Re: **Agency Response, Closure Request, and Contingency Work Plan**  
2001 Fruitvale Avenue  
Oakland, California 94601  
Incident # 97109122  
Cambria Project # 244-1296-006

## RESPONSES TO COMMENTS

**Site Vicinity/Area Well  
 Survey Map**  
 (1/2 Mile Radius)

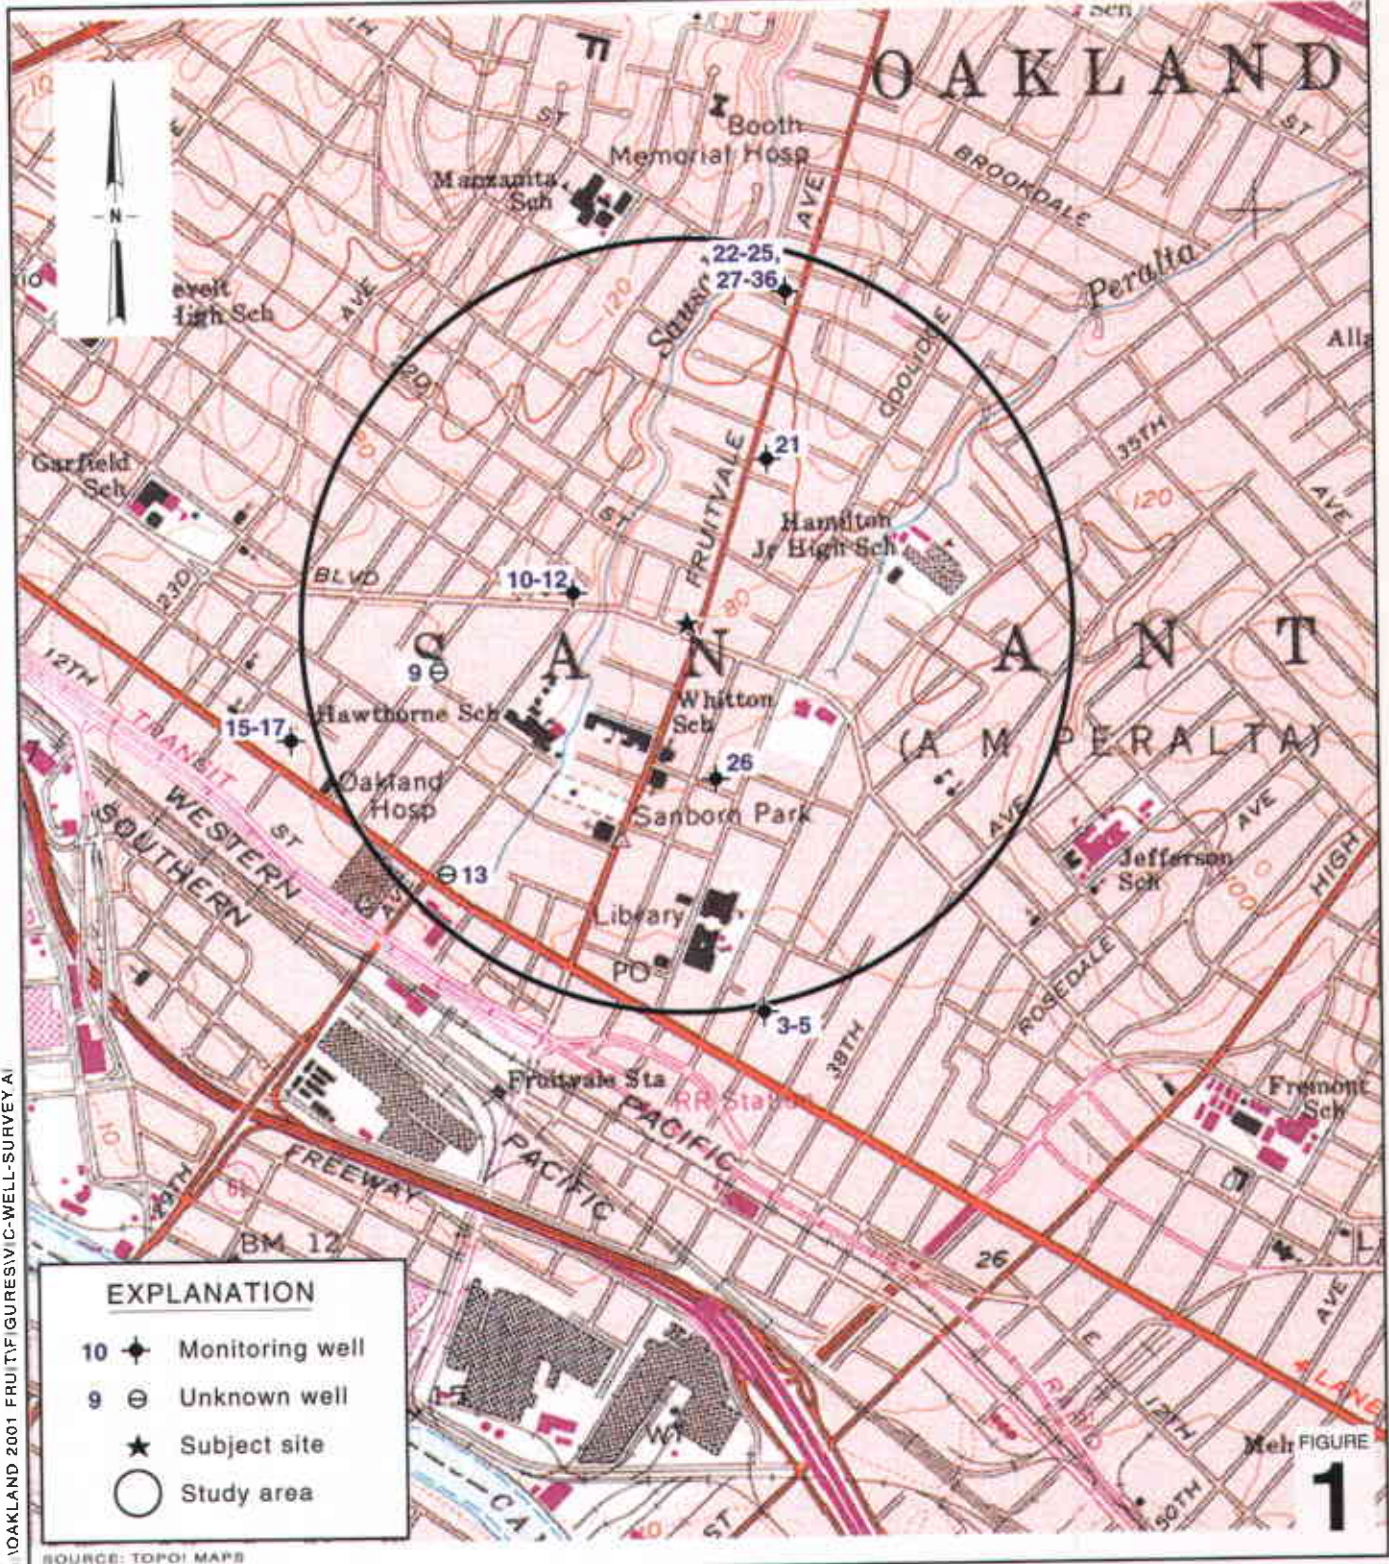
*Comment 2) Please provide a to scale figure indicating the location of these samples and the assumed location of the former underground tanks, piping and dispensers.*

Figure 1 shows the site's location and the location of wells identified during a well search of State Water Resources Board records. Figure 2 is a site plan (revised slightly from our previous site plan) based on a Shell Oil Company "Plot Plan, Modernization of S.S. L-530", dated January 18, 1957. A copy of the original plot plan is included as Attachment B. A full-size blueprint of the 1957 plot plan was located by Shell in its records and provided to Cambria. The locations of all known soil and groundwater samples, as scaled from field notes and previous reports, are shown on the updated Figure 2.

**Proposed Monitoring Well and Soil Boring Locations**

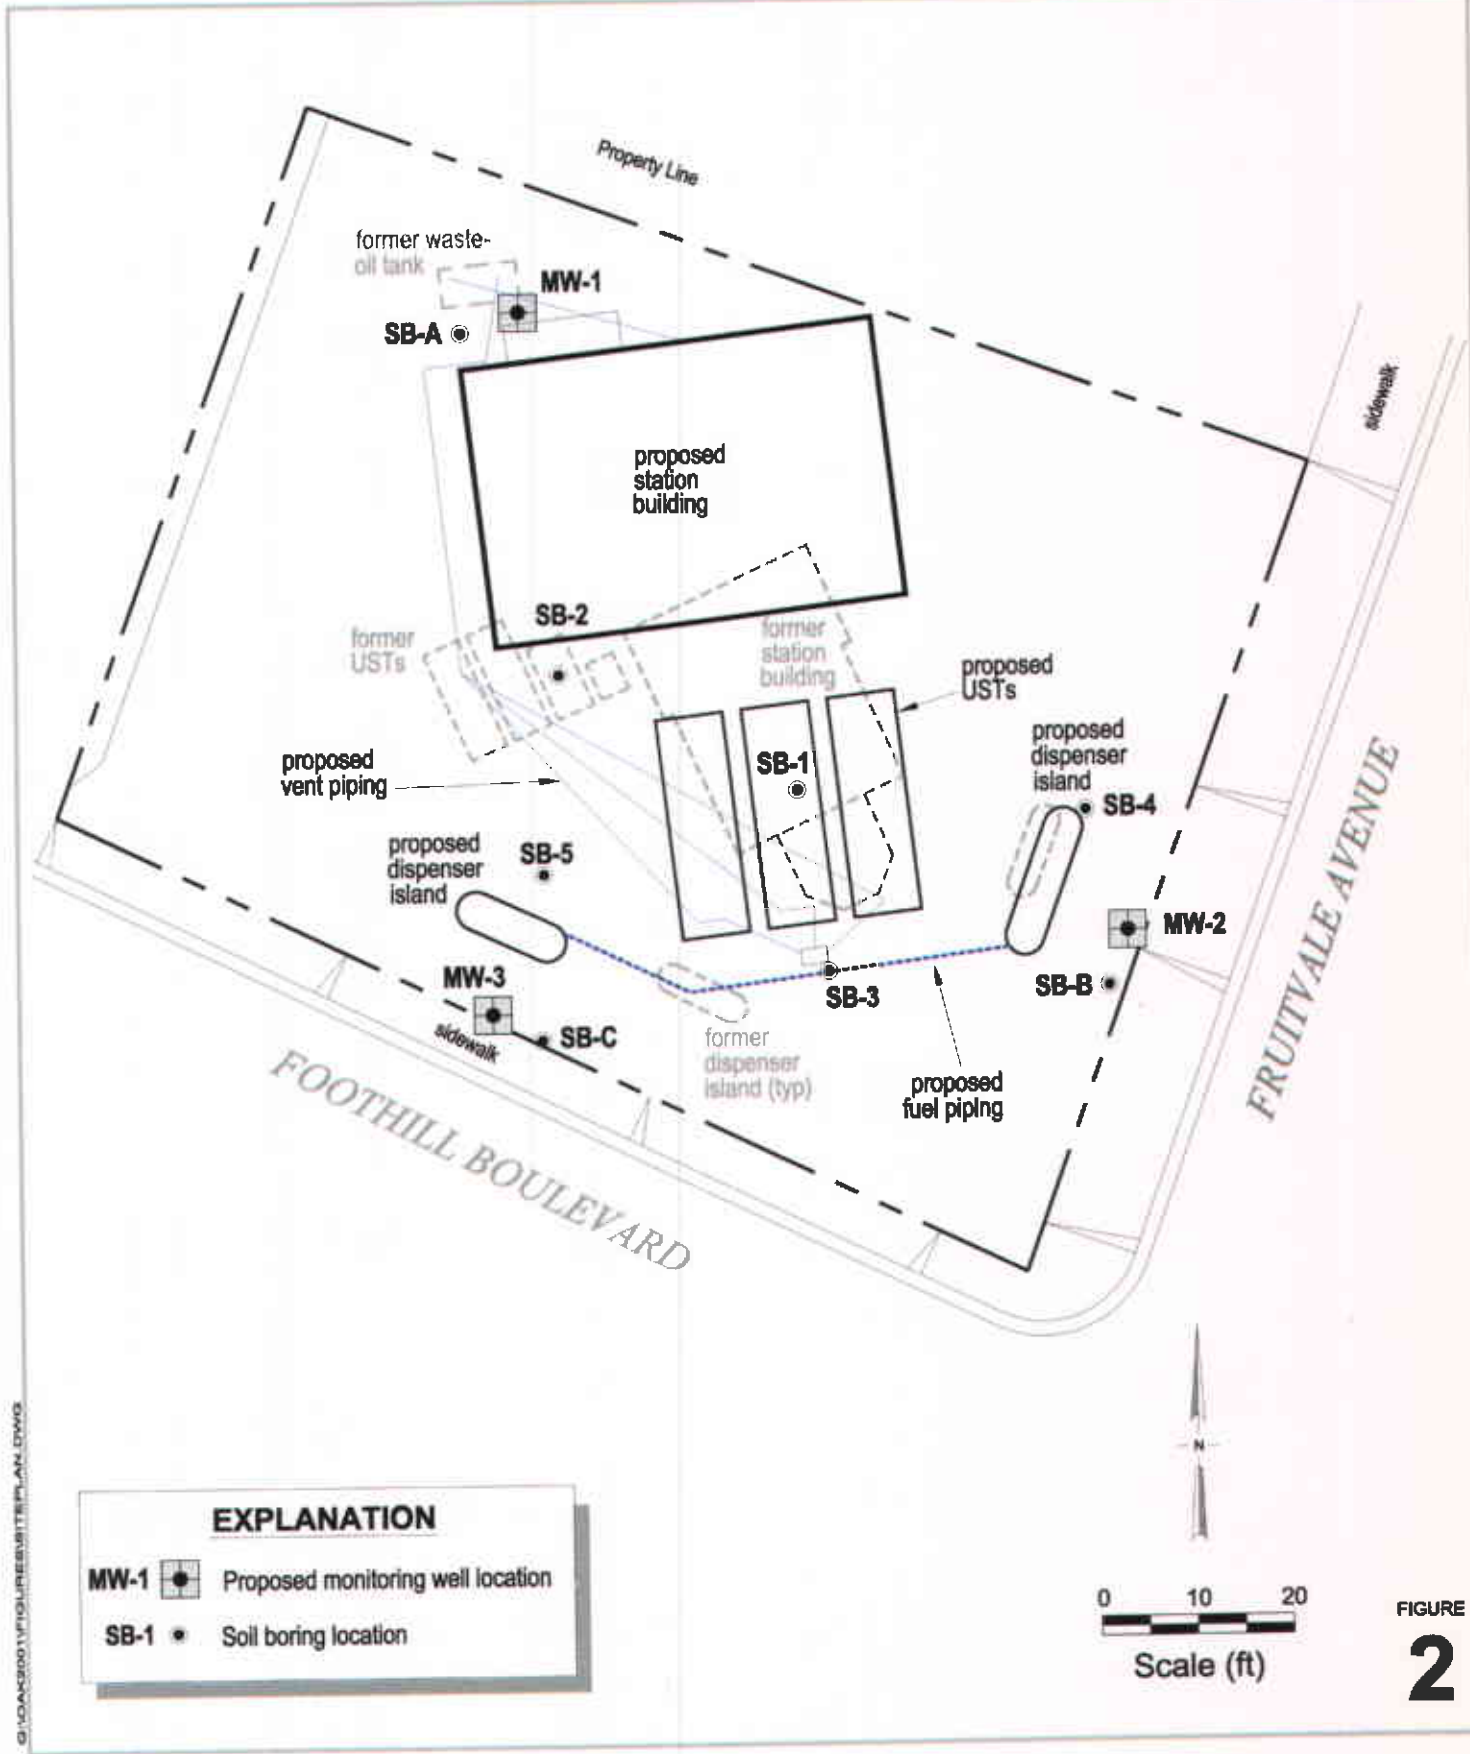
***Comment 4) Examine the need to better characterize the site given the number and locations of the existing samples. Note how the number and location of samples compare to the number and locations of samples normally taken during tank removals.***

As shown on Figure 2, soil and groundwater samples have been collected as follows, and their locations are referenced to the "existing" and "proposed" structures shown on the 1957 modernization plan:

To monitor hydrocarbon concentrations in groundwater and groundwater elevations beneath the site, we propose installing three 2-inch diameter monitoring wells on-site in the vicinity of the former waste oil UST and adjacent to the property boundaries along Foothill Boulevard and Fruitvale Avenue, adjacent to previous soil boring locations SB-A, SB-B and SB-C (Figure 2)

**Geologic Cross Sections  
 A - A' and B - B'**

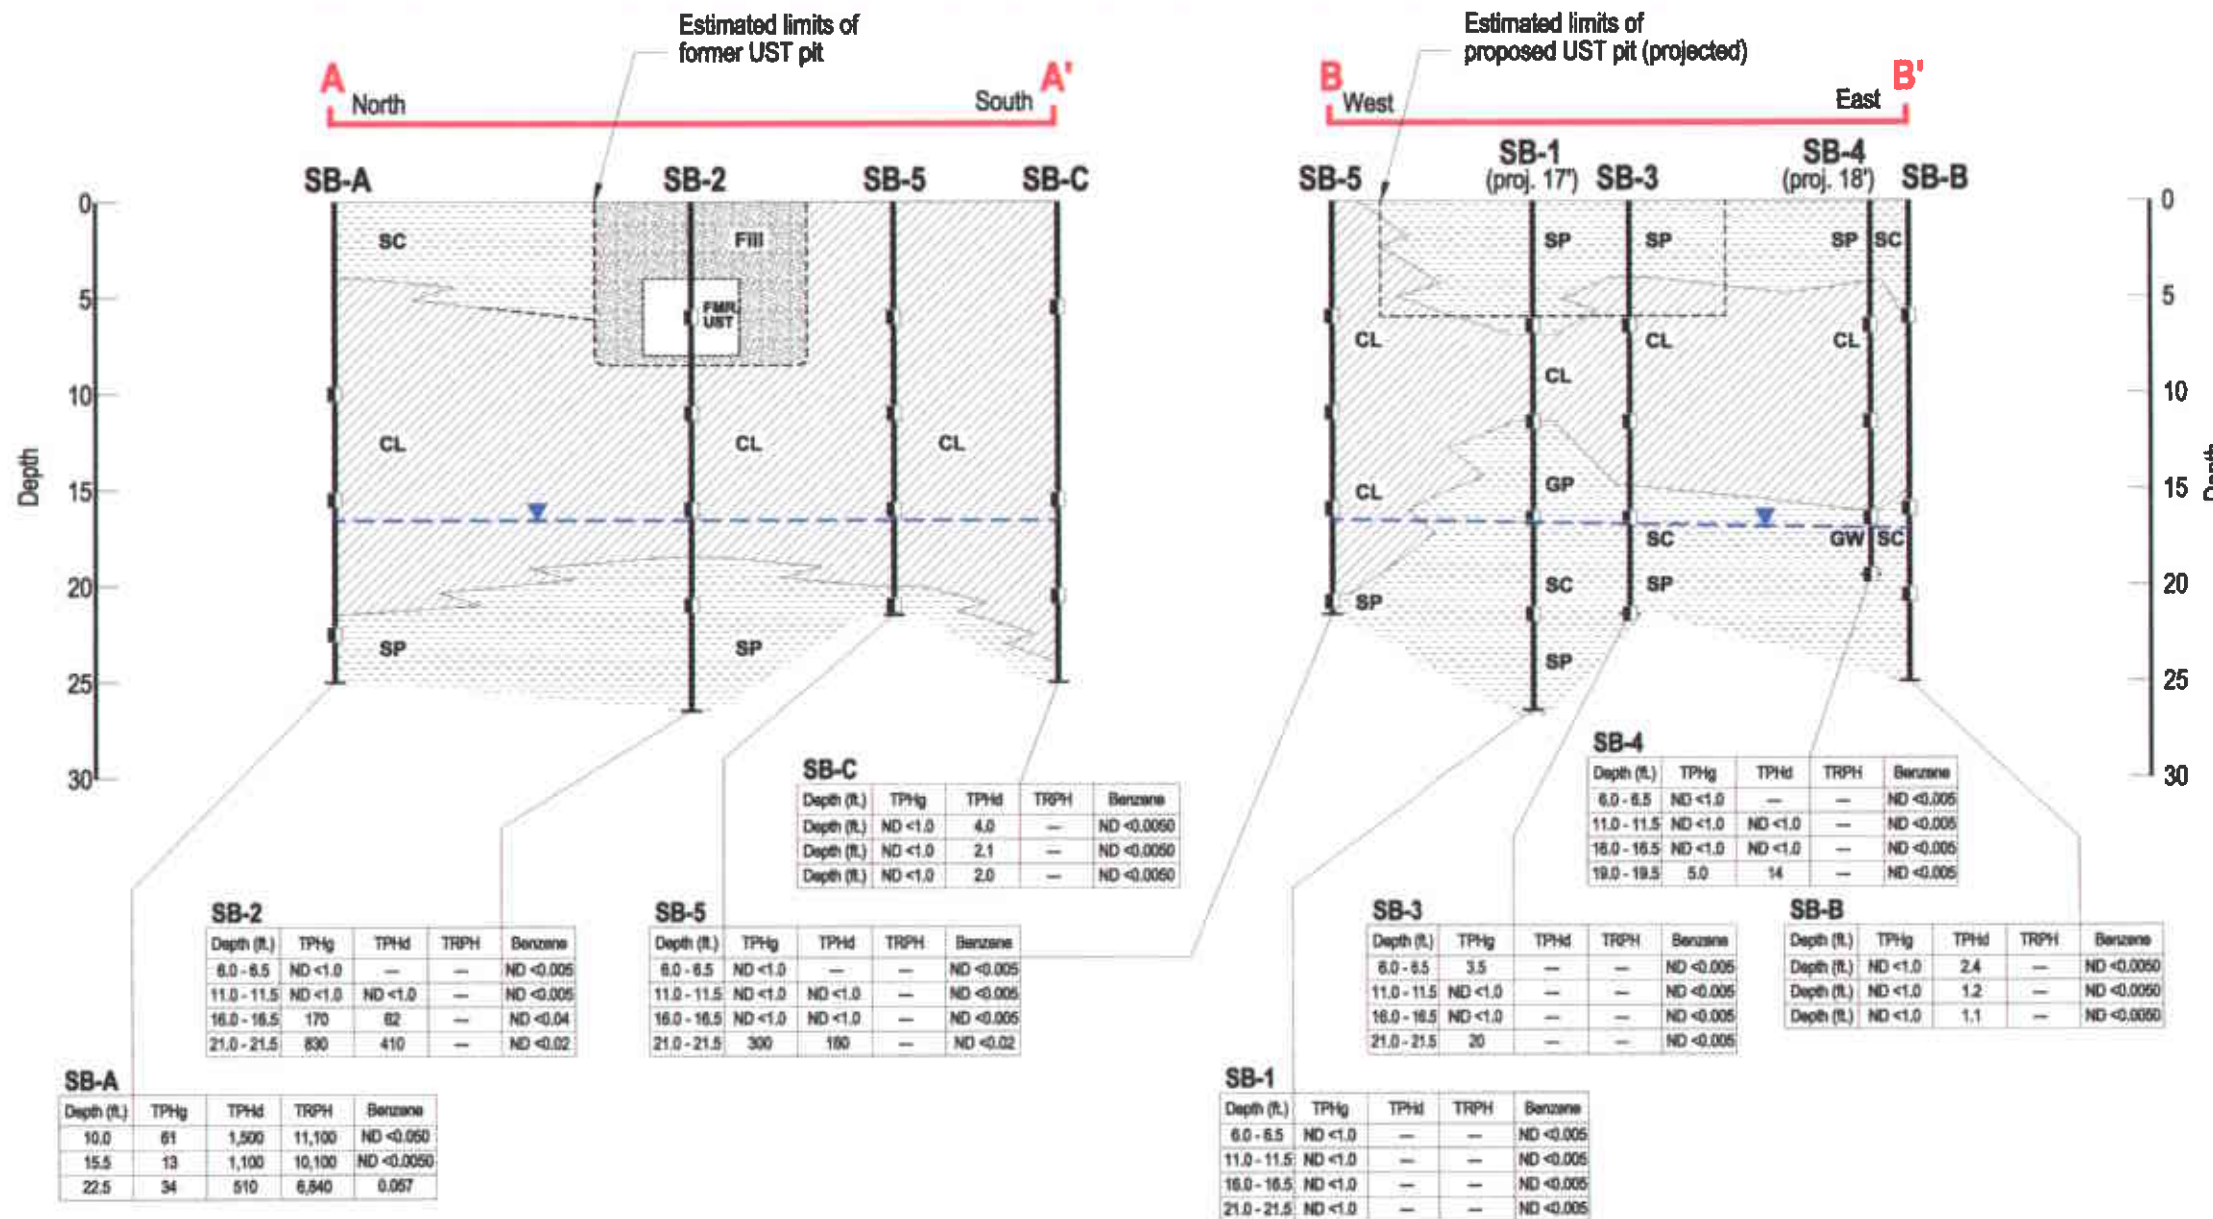
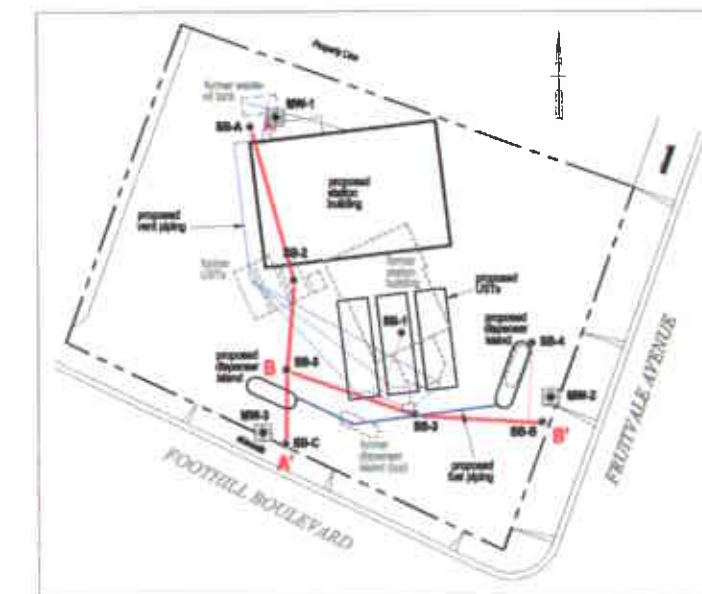
***Comment 3) Please provide at least two cross-sectional diagrams (north-south, east-west) indicating soil concentrations and soil type.***

Cross sections A-A' and B-B' are presented as Figure 3. The sample depths and concentrations of total petroleum hydrocarbons as gasoline (TPHg), total petroleum hydrocarbons as diesel (TPHd), total recoverable petroleum hydrocarbons (TRPH), and benzene are also shown on the cross-sections. Copies of all soil boring logs are presented as Attachment C.
